Re: Revised Permit Renewal Application  
Triassic Park Waste Disposal Facility

## Responses to NMED Comments on Part A and Part B Permit Renewal Application for the Triassic Park Waste Disposal Facility

Following are New Mexico Environment Department (NMED) comments dated February 5, 2013, and DBS&A responses regarding the Part A and B Permit Renewal Application for the Triassic Park Waste Disposal Facility, October 17, 2011, Revision 1 - April 30, 2012 (Renewal Application) dated April 30, 2012. These responses have been prepared based on guidance from the NMED at a meeting in Santa Fe on May 15, 2013, and on a conference call on June 18, 2013. Issues discussed in these responses have been incorporated into Revision 2 of the permit renewal documents, where applicable.

TYPICAL VADOSE ZONE MONITORING WELL INSTALLATION DETAIL

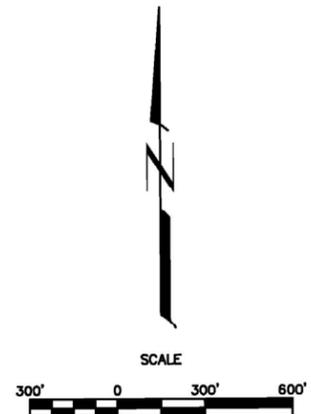
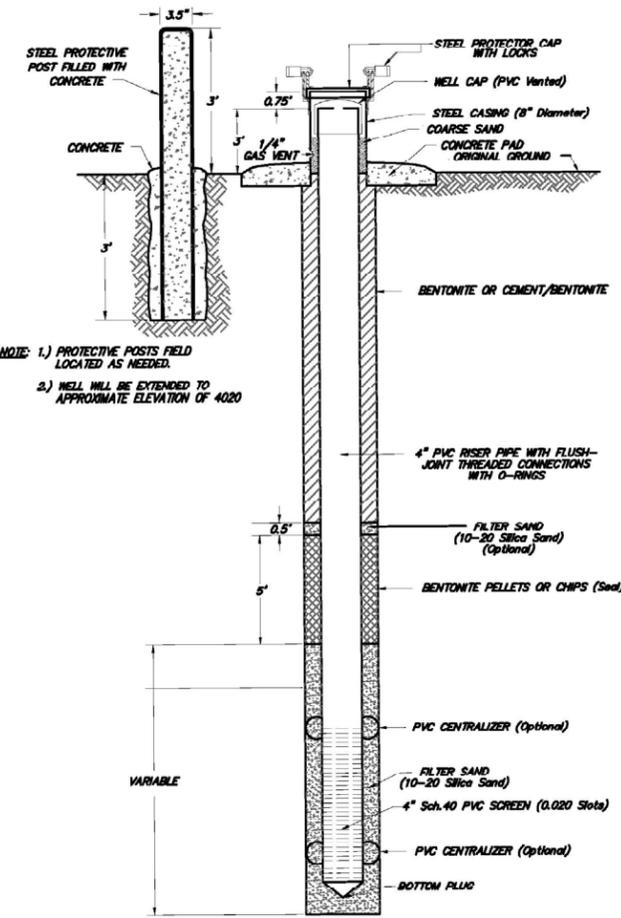
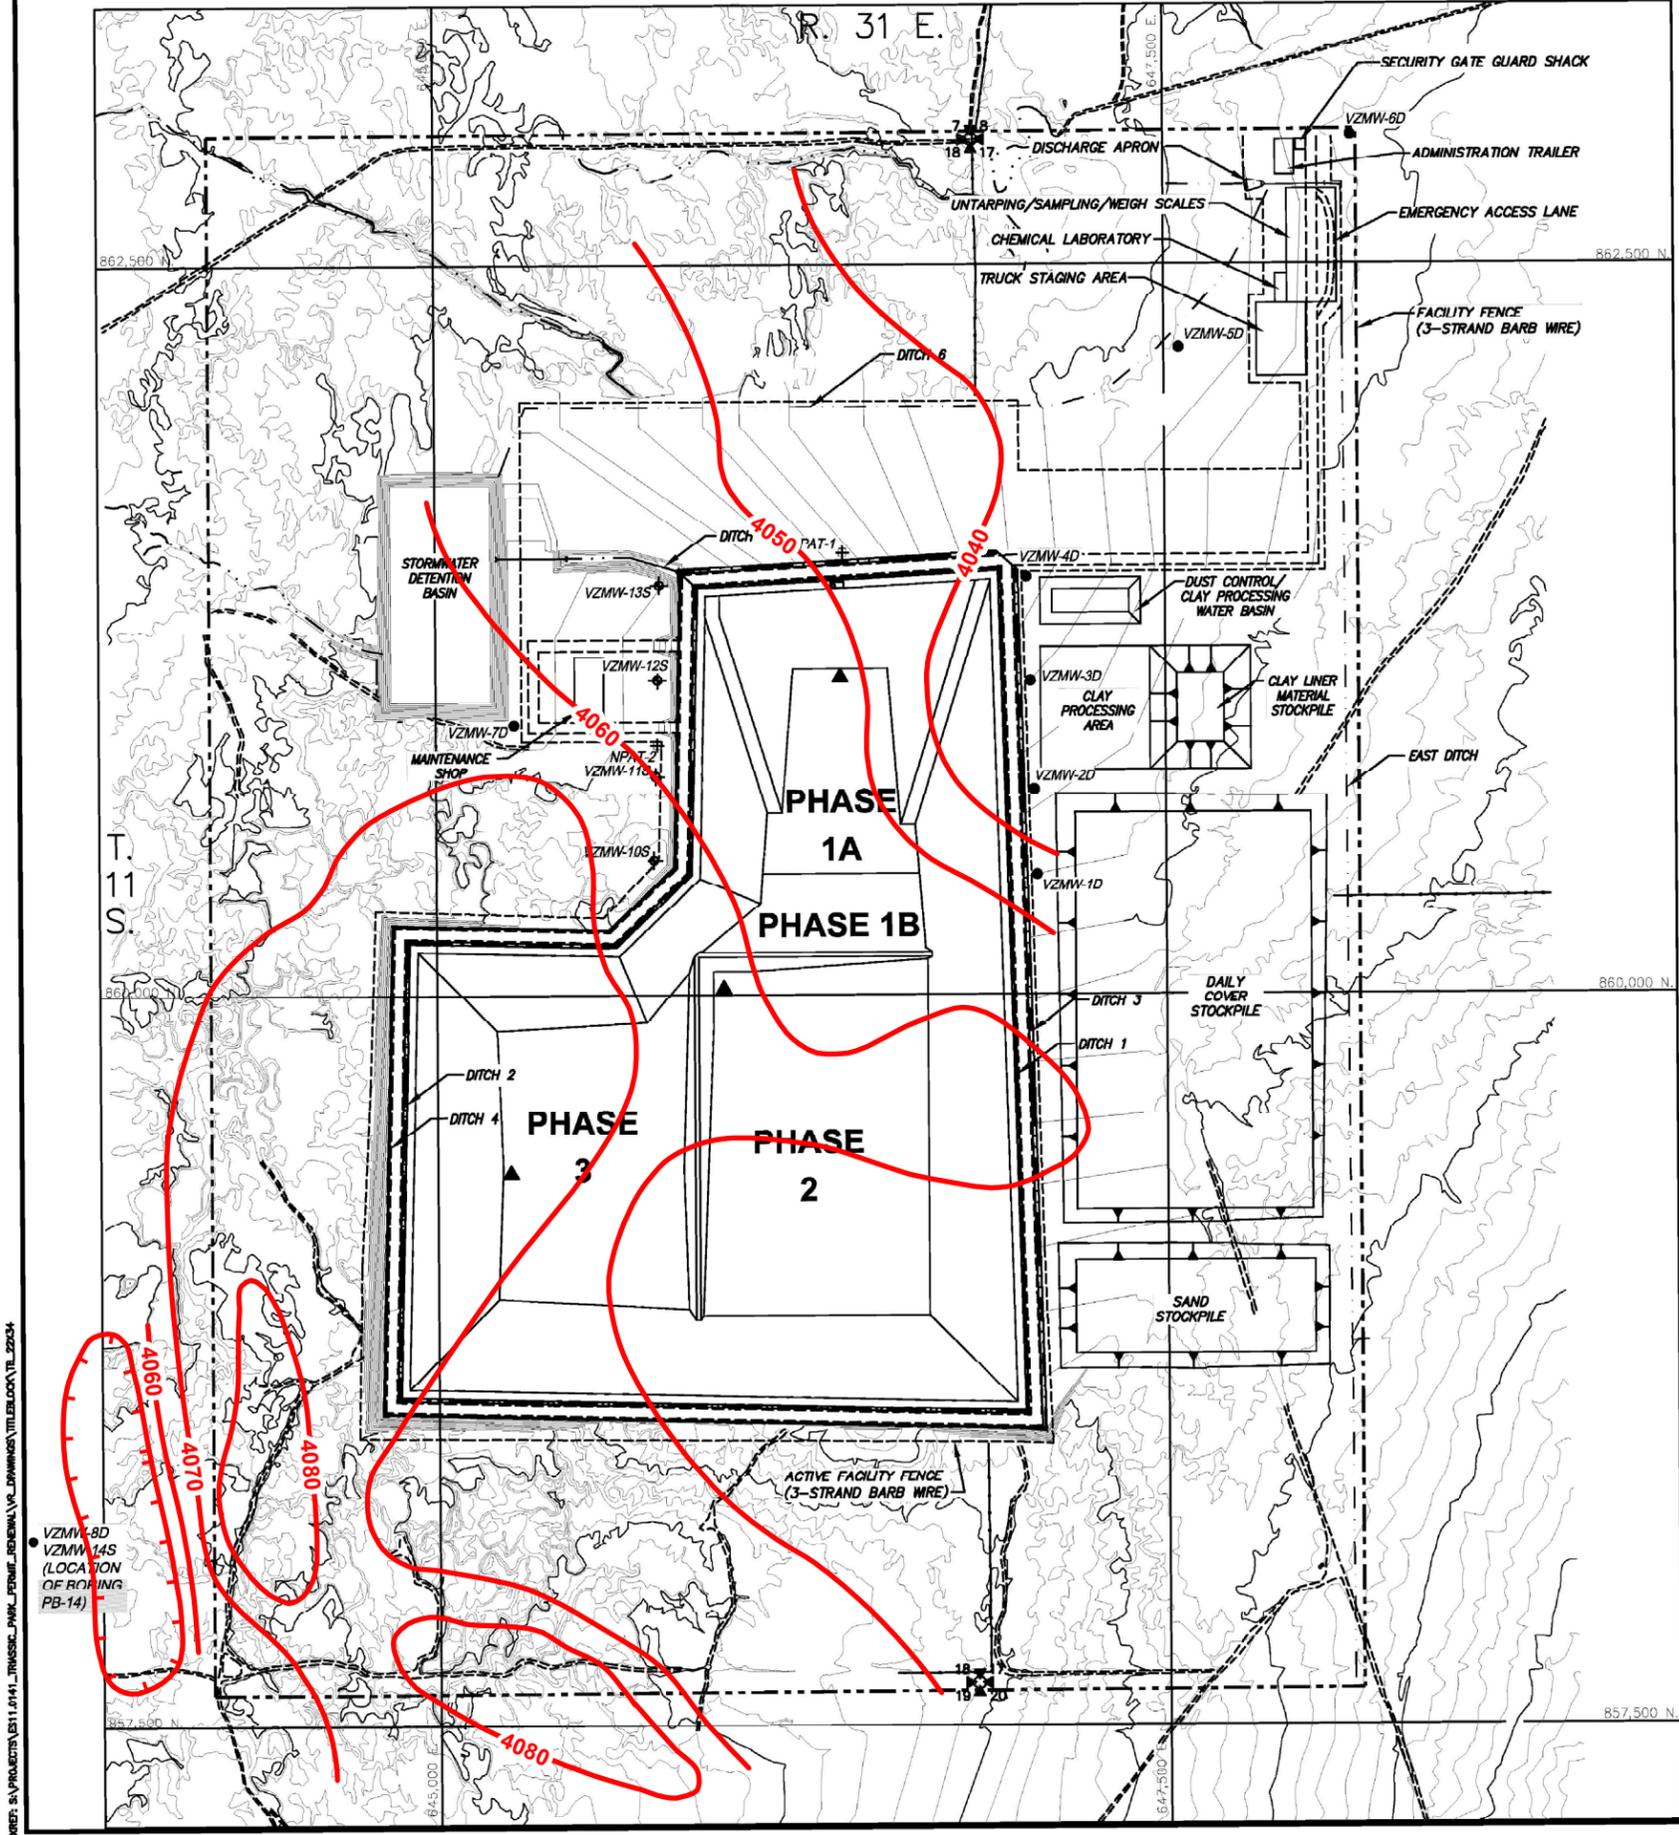
*61. Attachment L1, Drawing 4 (revised), Facility Layout: The drawing provides "Typical Vadose Zone Monitoring Well Installation Detail", but the vertical distance between the top of the screen and the bottom of the bentonite seal is not defined. Also See comment# 58 on Attachment I (Vadose Zone Monitoring System Work Plan), elimination of Drawing 2 from Attachment I has left the completion depth of these monitoring wells ambiguous in the current design. Note that specifications for the neutron probe access well construction are not shown on the drawings, but are generally described in Section 2.2.2.3 of Attachment I. However, the target depth interval for completion of the neutron probe access wells is not provided. Provide the missing information.*

Monitoring well installation details have been clarified on Drawing 4 to match text and figures in Attachment I, Vadose Zone Monitoring Plan. Figure 2a from Attachment I has been included as a second sheet for Drawing 4 to provide further clarification.
